LAKESIDE UNION SCHOOL DISTRICT
BOARD OF TRUSTEES
REGULAR MEETING
AGENDA

May 12, 2026
6:30 P.M.

(16) Approval of Change Order CO-01 from Black/Hall Construction for Project: 8 CR, 2 RR at Lakeside School in the Amount of $19,273.68.

(17) Approval of Change Order CO-02 from Black/Hall Construction for Project: 8 CR, 2 RR at Lakeside School in the Amount of $152,642.03.

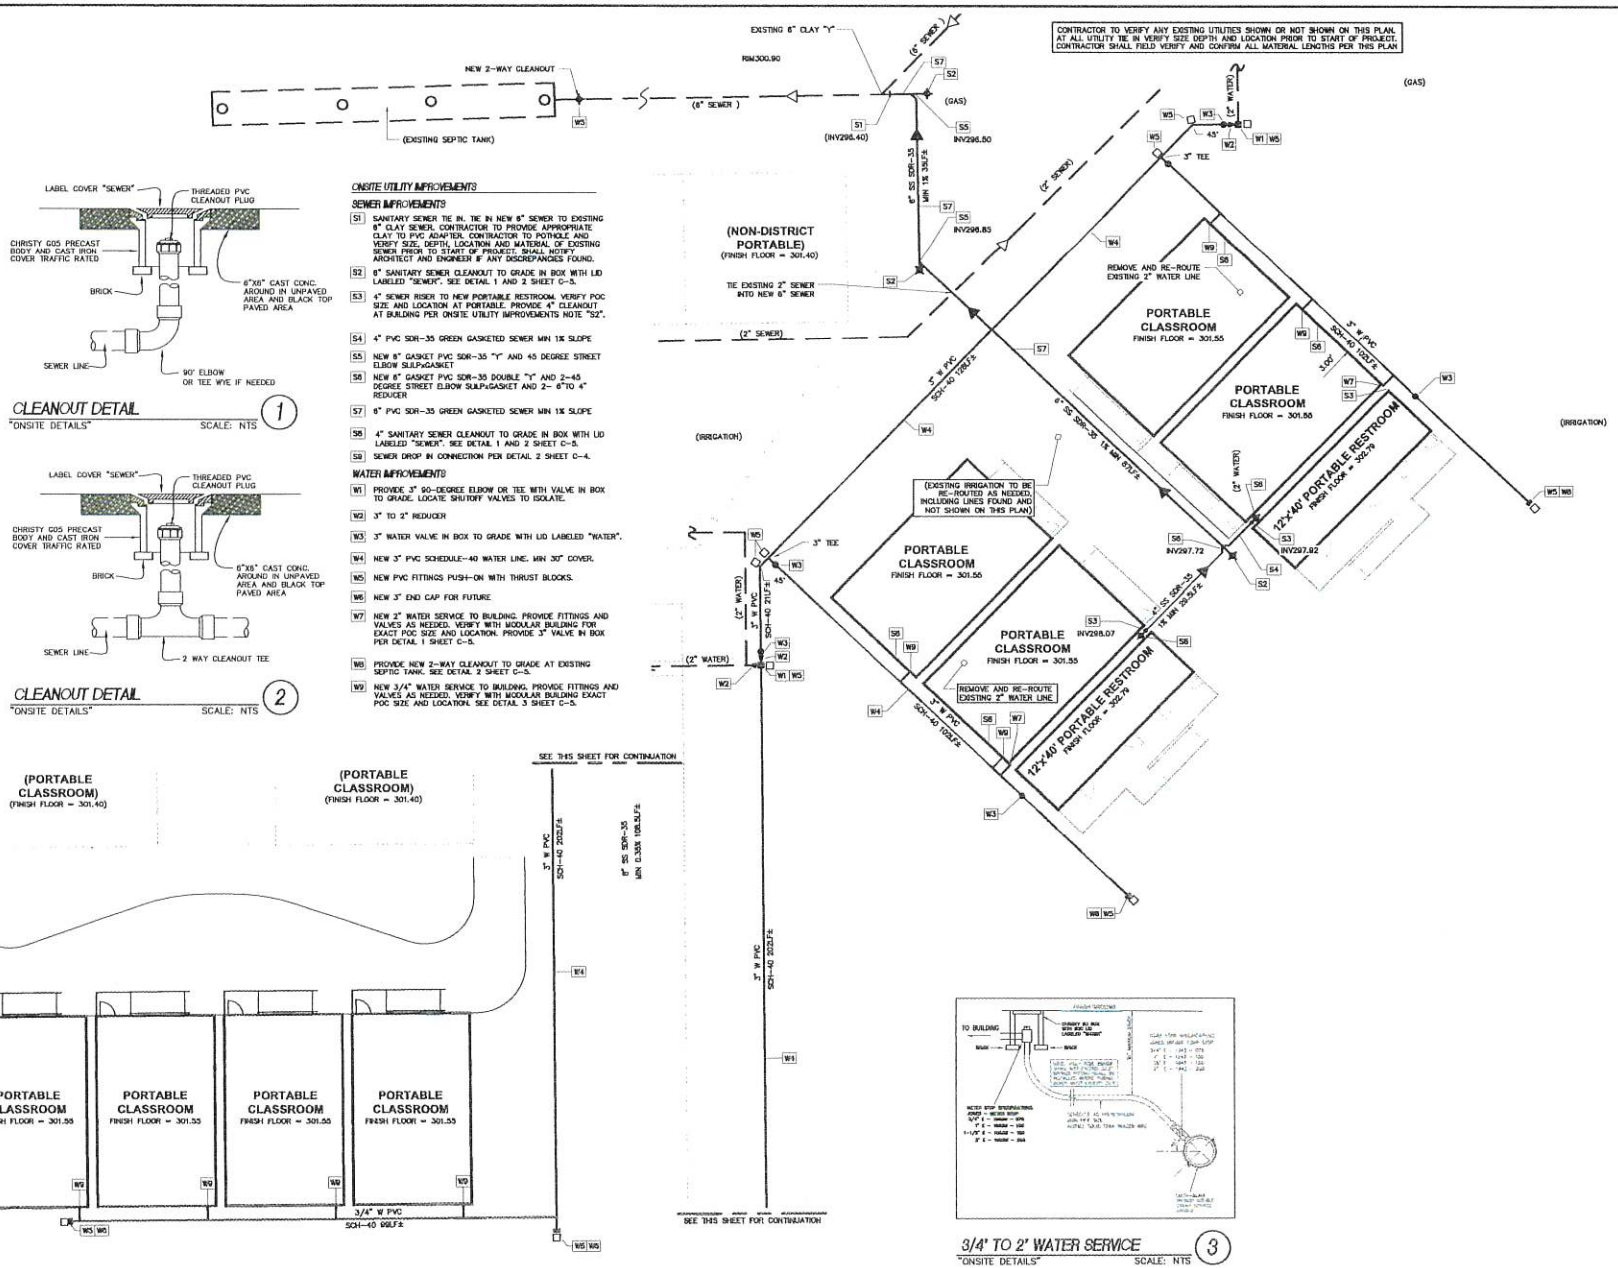
The location of the existing storm drain and sewer lines allowed the design team to re-route waste and water lines to this location and reduce the amount of new plumbing.

With these revisions, manhole covers have been removed from the scope of work as well.

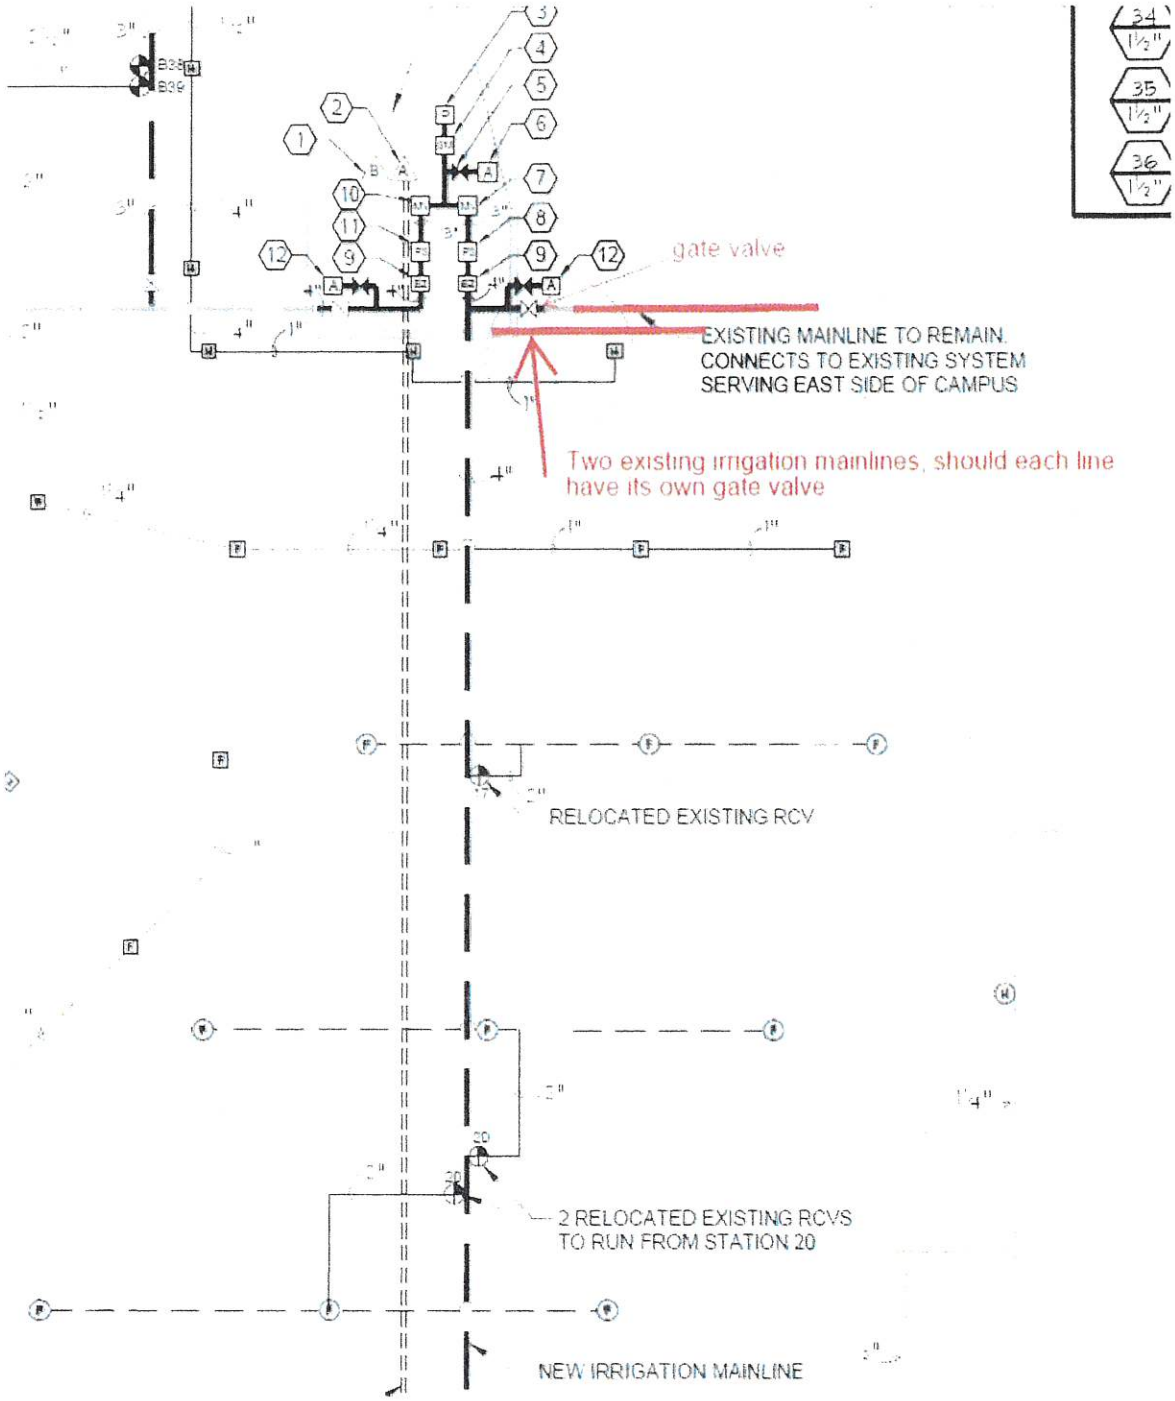
This issue was raised at our meeting on-site last week,2/25.2026. Kern Sprinklers informed the group that there is an additional 4" mainline to the east. Our plans only indicate one mainline to the east of the well site. There should be a 4" gate valve installed on each of the two mainlines to provide the ability to isolate each individually in the event of a break or needed repair. The plans provided last week only show one of the gate valves to the east, because we had no information on where the other was located. Jim Rios (Rios Design Studio, LLC)

SHEET IDENTIFICATION NUMBER
L10

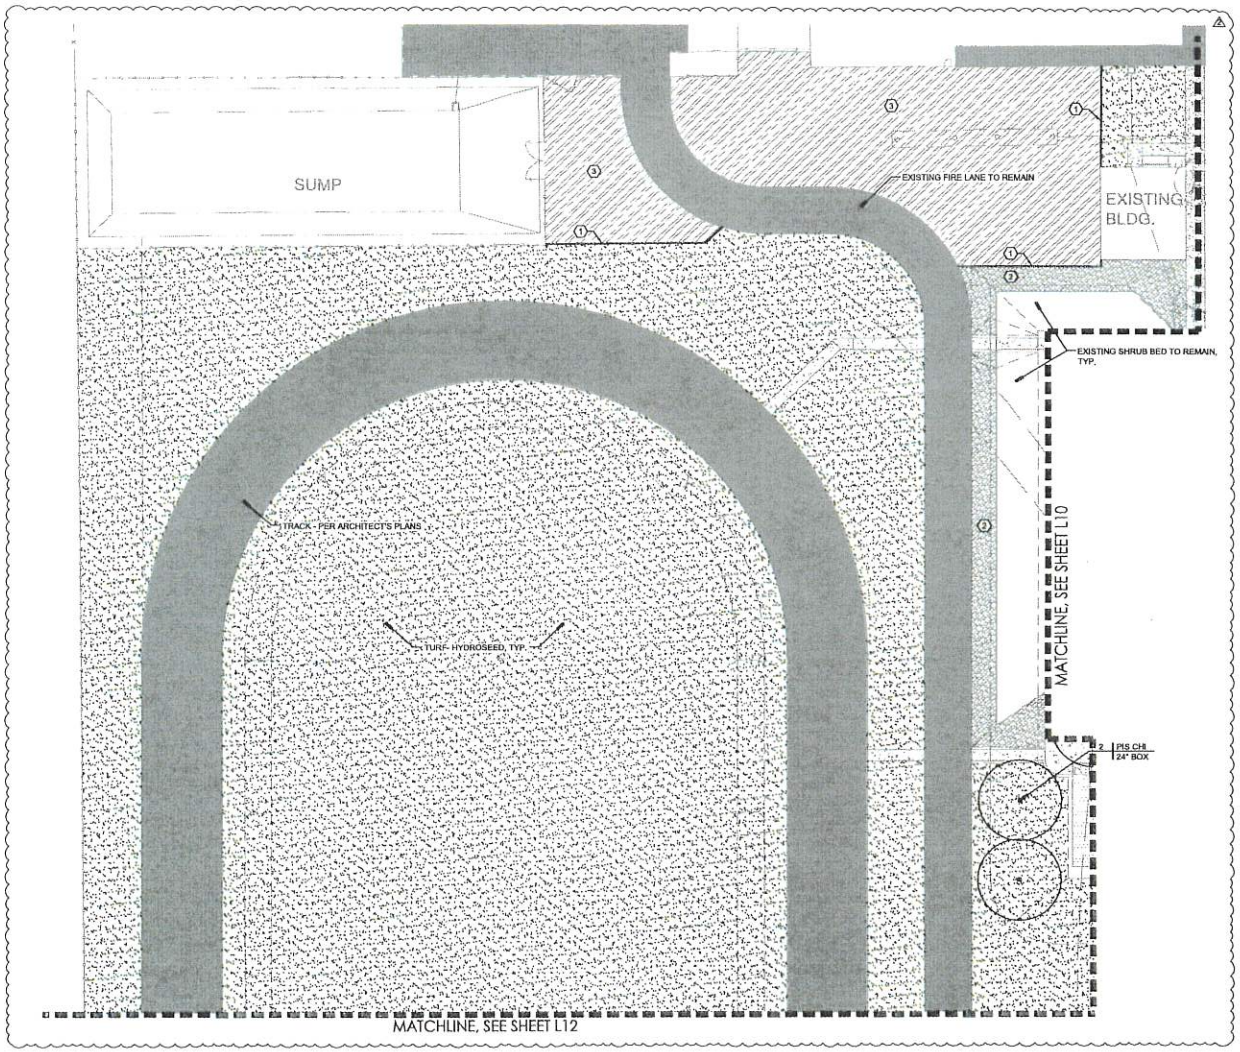
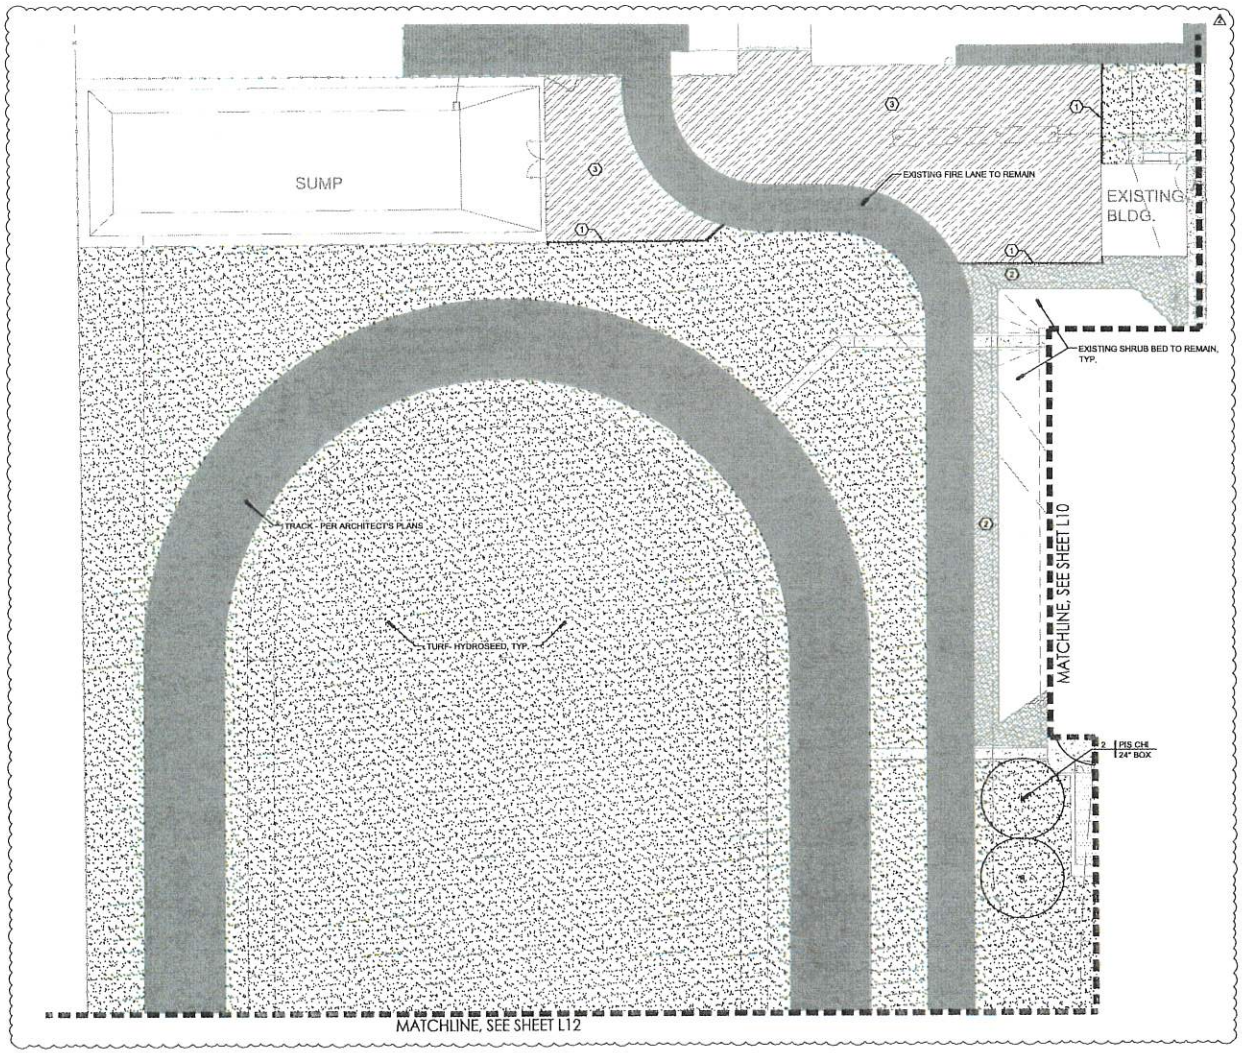
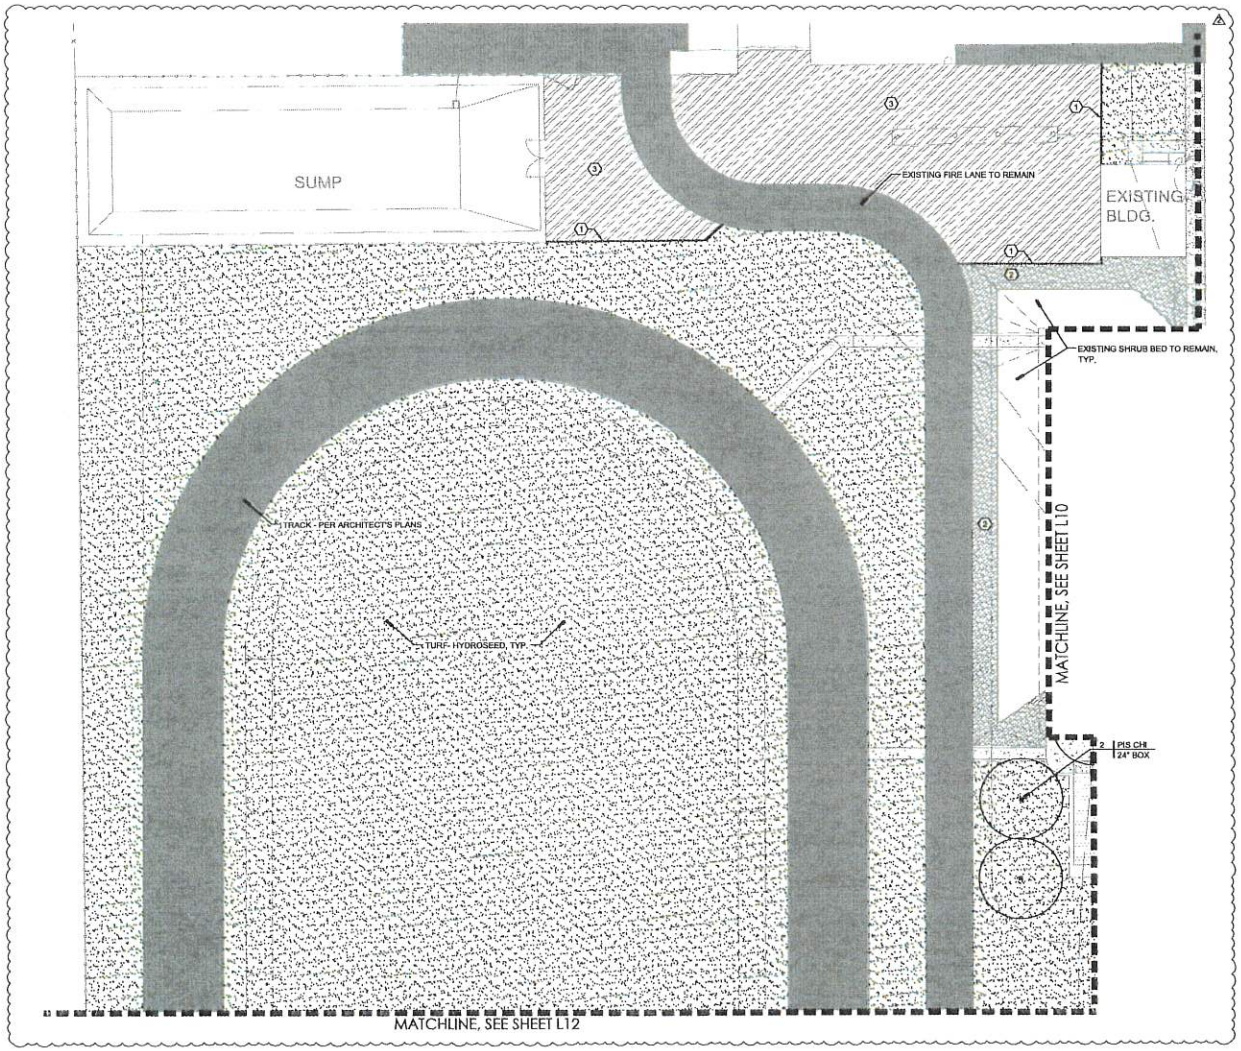
Item #3 **Miscellaneous**
Sheet L-11:
- Area north of fire lane finish materials and mow strip

ITEM #1

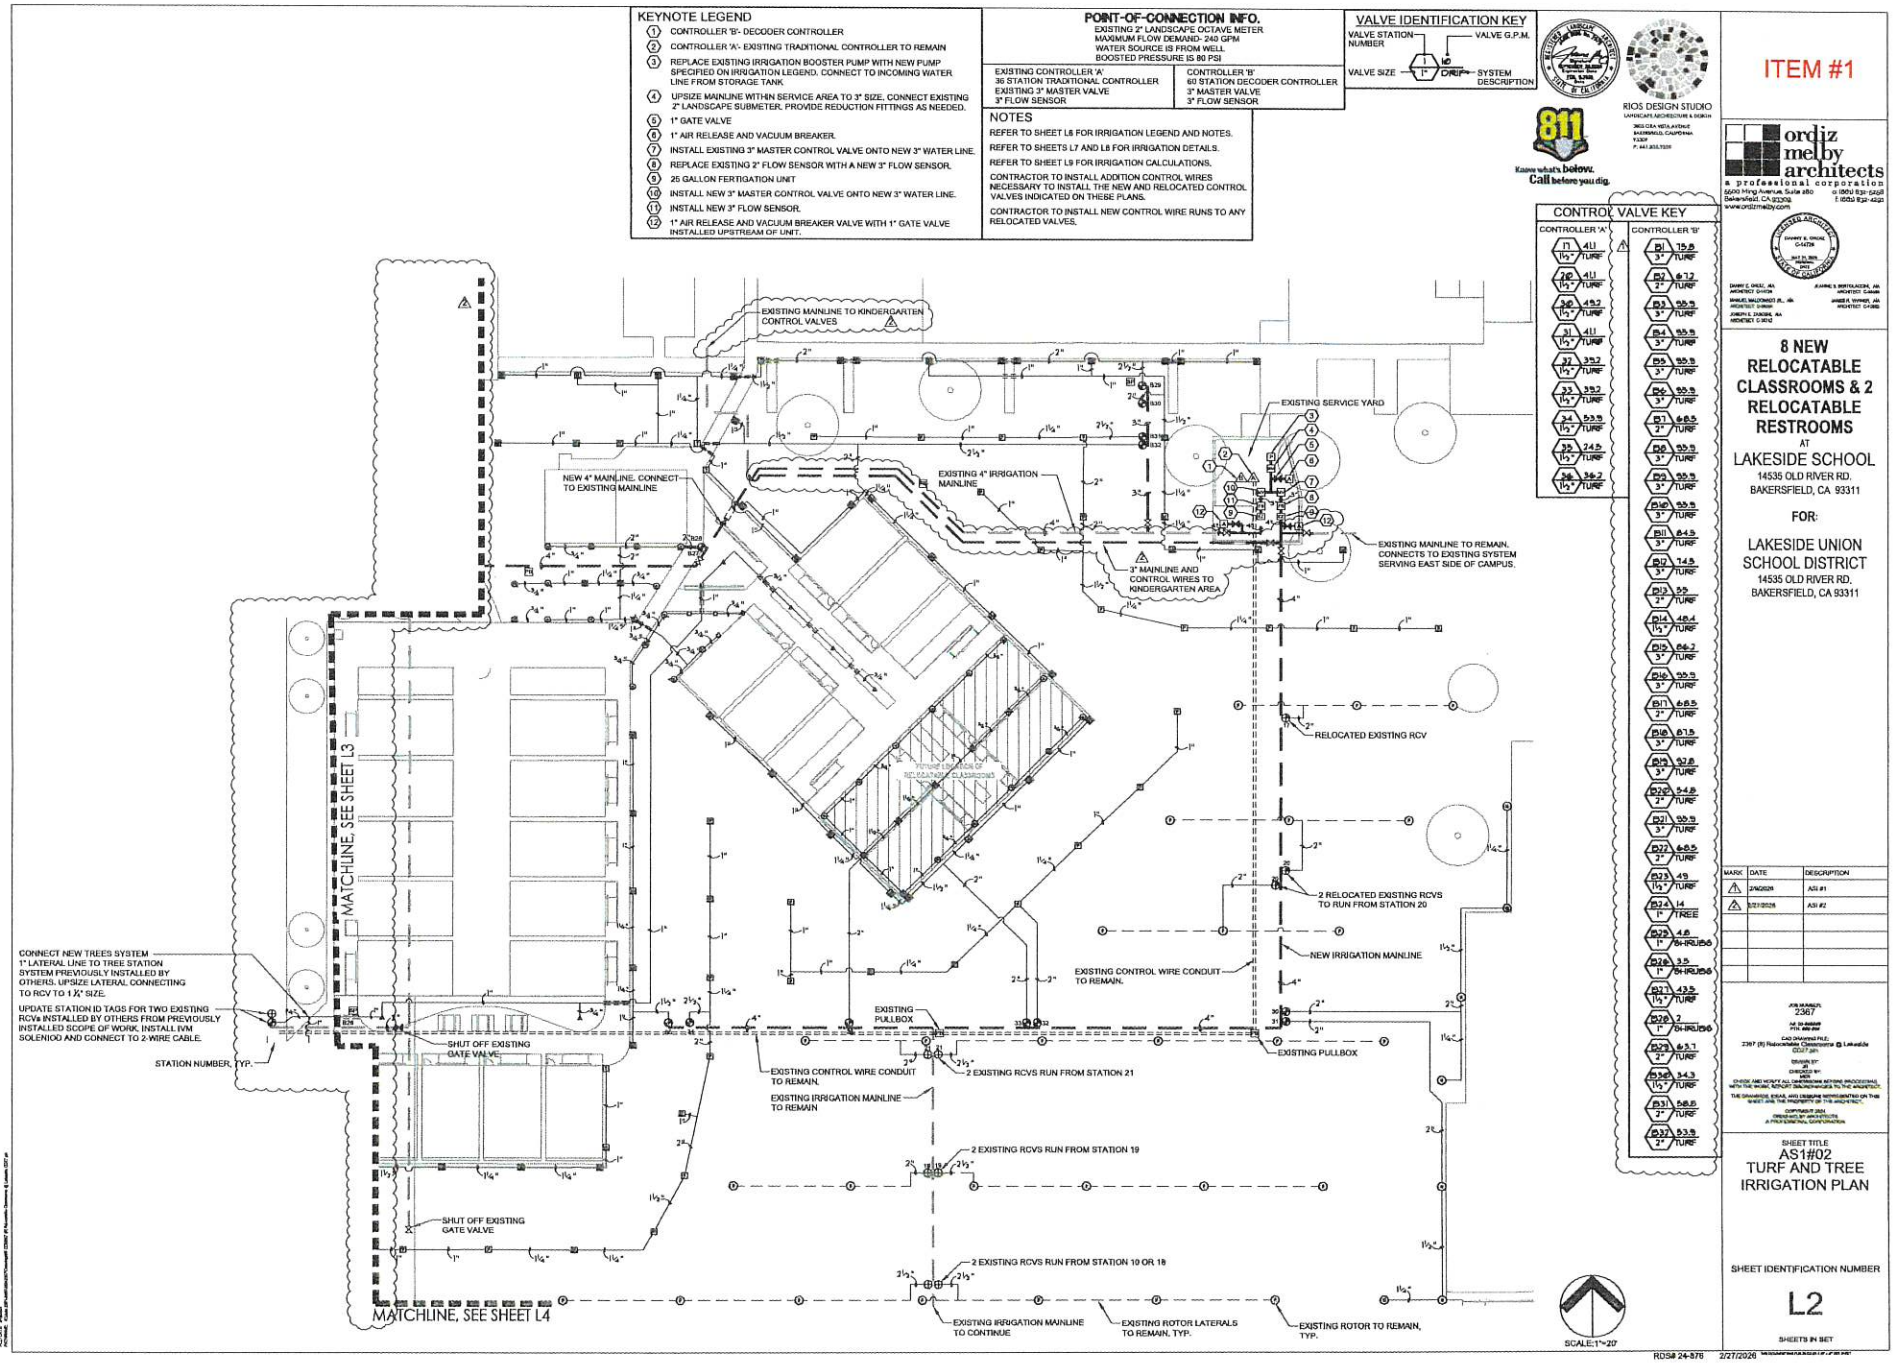
Item #2 **Sprinkler removal**
Sheet L-3:
- sprinkler and turf removed from the area north of the fire lane.
- Irrigation mainline and 1" conduit to be bored under the existing fire lane, as opposed to saw-cutting the fire lane.
- Existing mainline under the existing relocatable buildings to be capped and abandoned in-place.
